## ORIGINATION FORM

Proposed Revisions to a Standard Plans Index  
(Please provide all information — Incomplete forms will be returned)

Index Number: 425-060  
Sheet Number (s): 3 and 4 of 4  
Index Title: Back of Sidewalk Drainage

SHEET  
3 of 4

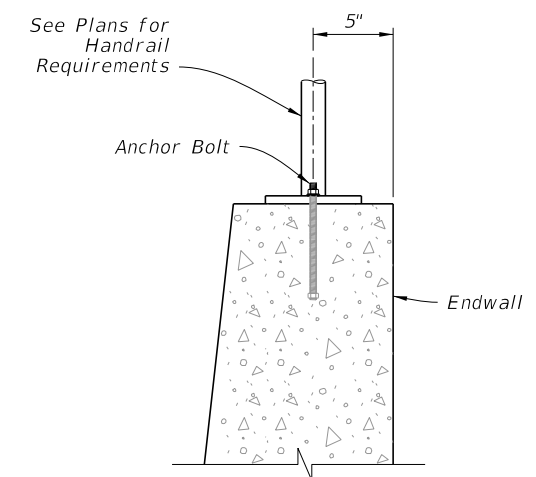
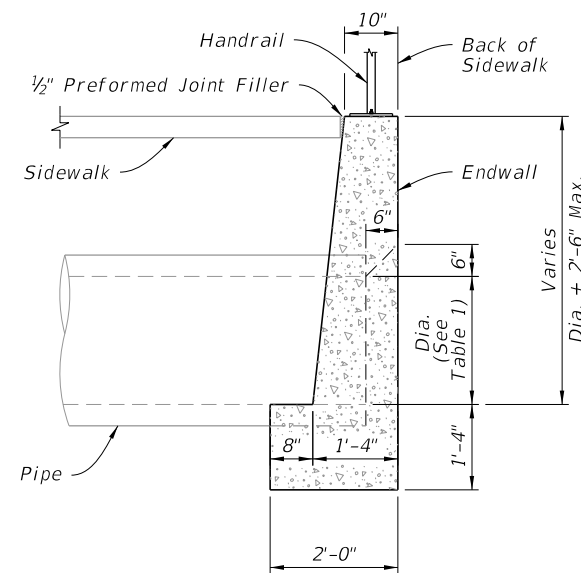
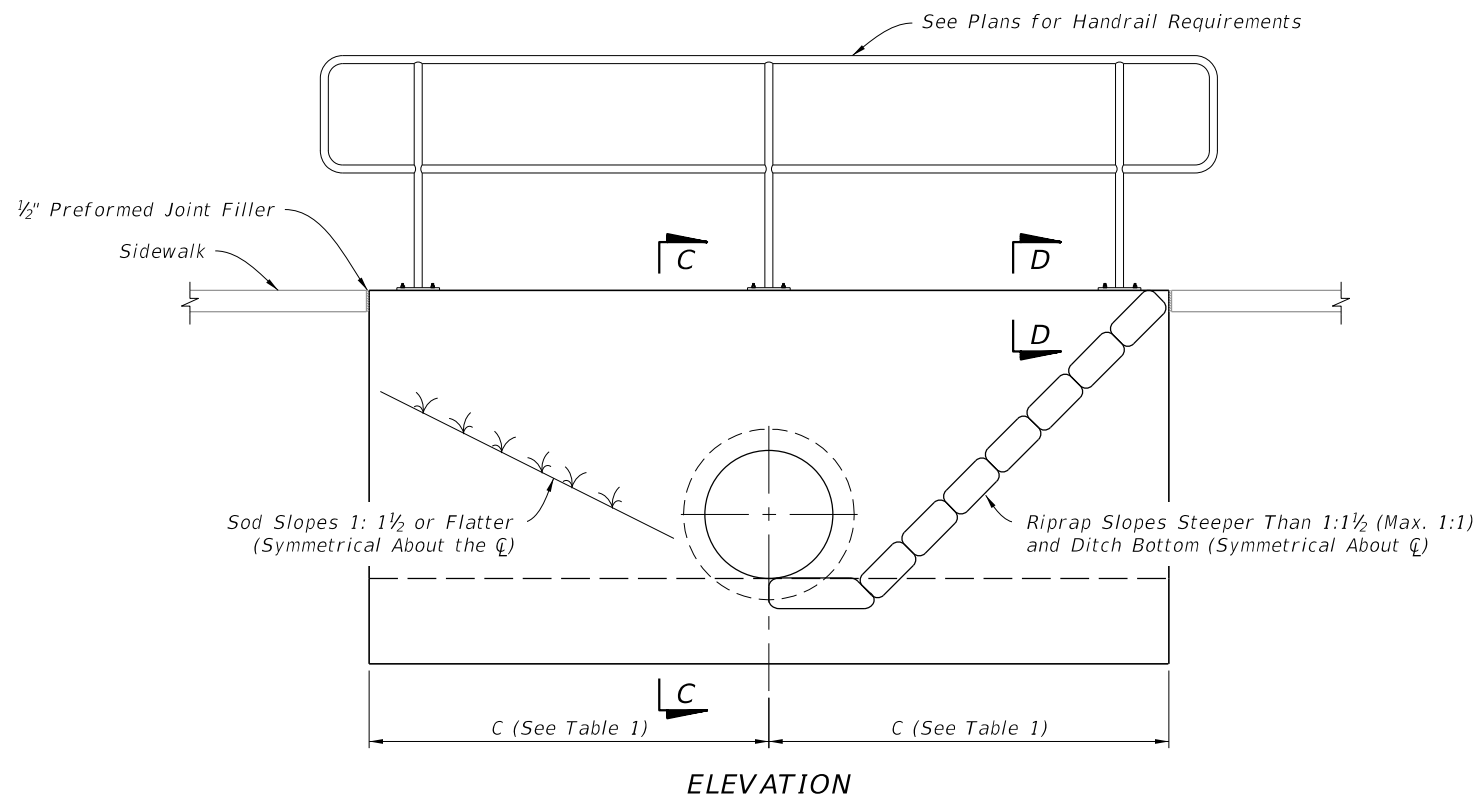
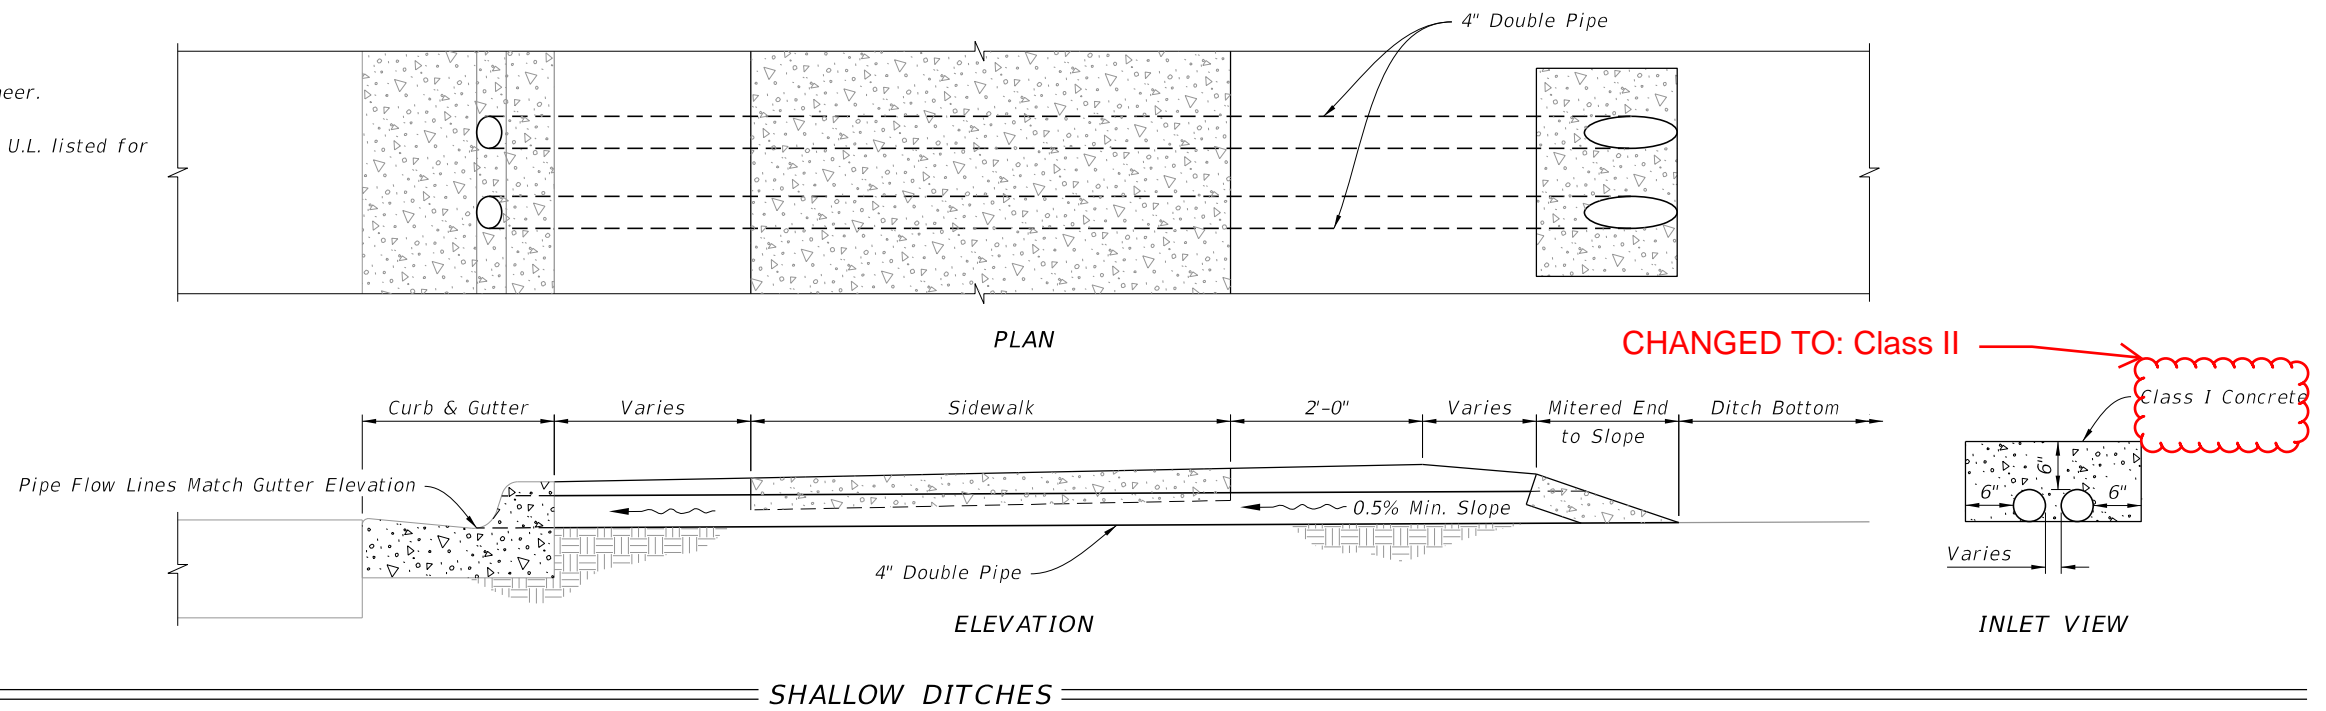
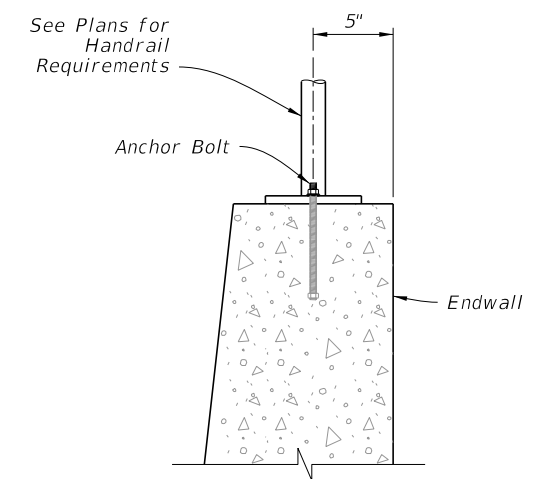
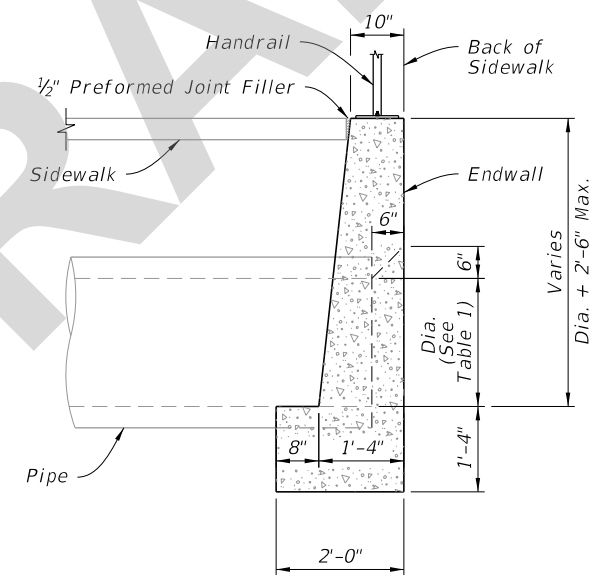
Sheet 3: Changed "Class I" to "Class II" in Table 1.

CHANGED TO: Class II

Changed to reflect Materials specification change that removes the designation for Class I Concrete.  
Please see the attached Standard Specification Section 346 DRAFT for the Class I revisions proposed by the State Materials Office.

SHEET  
4 of 4

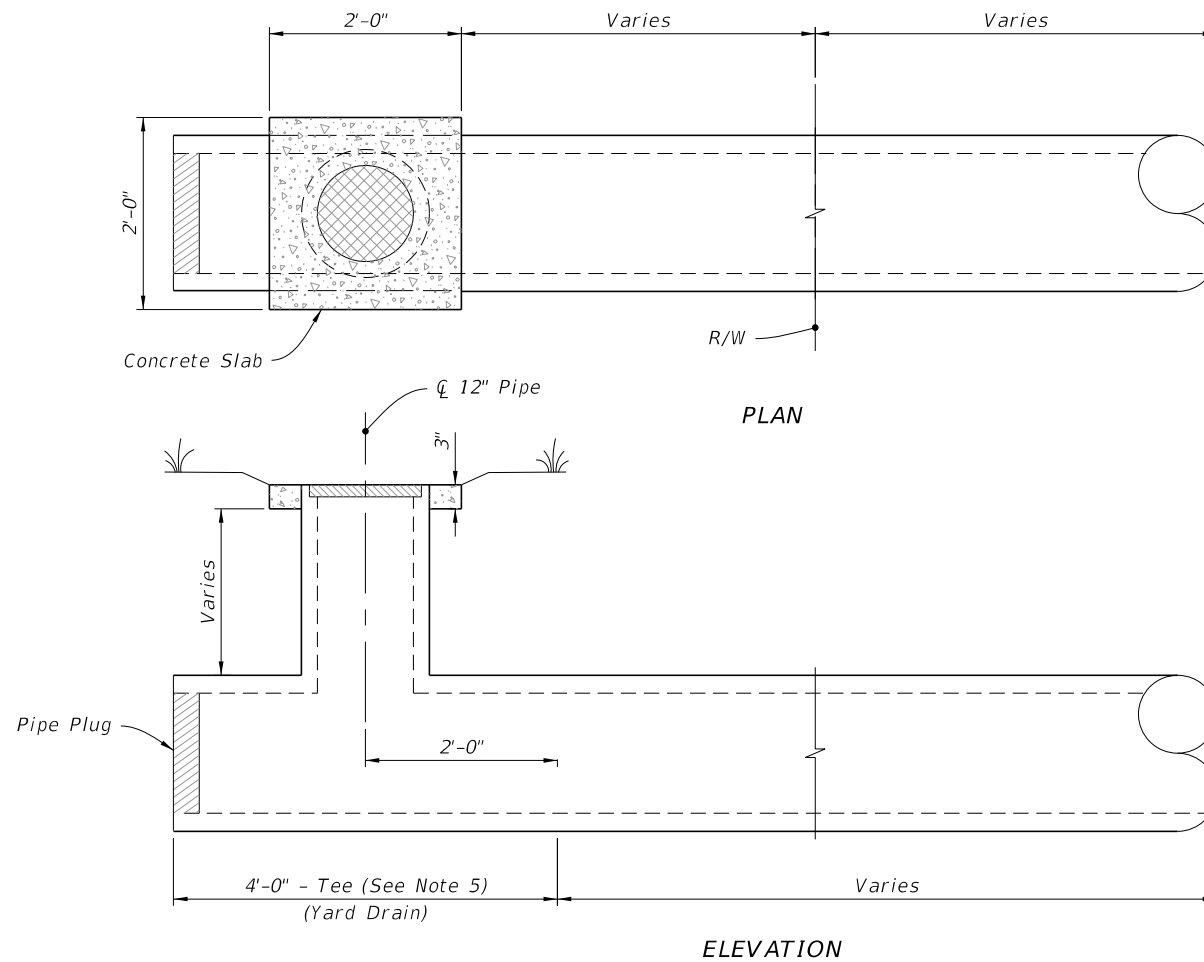
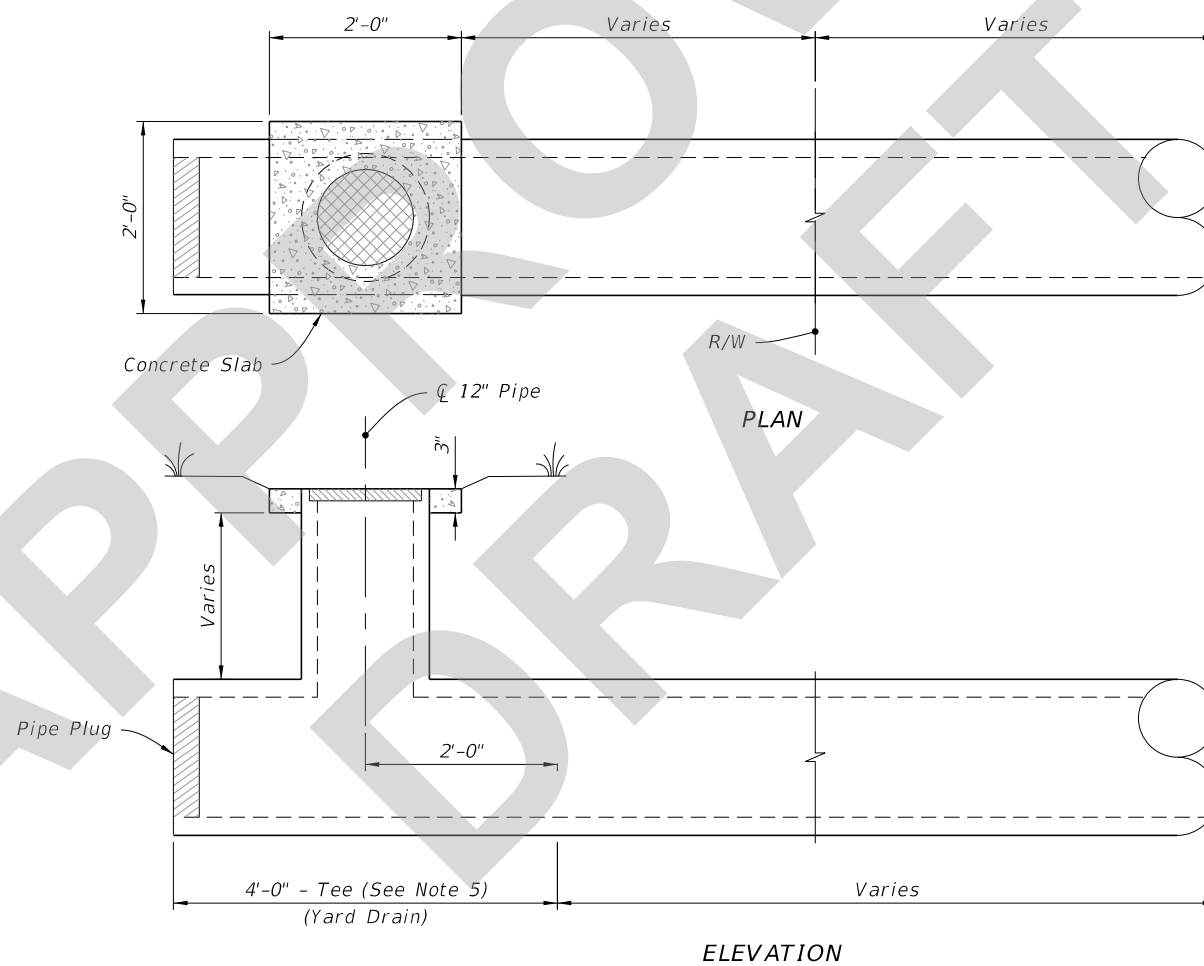
Sheet 4: : Changed "Class I" to "Class II" in the SHALLOW DITCHES - INLET VIEW detail.
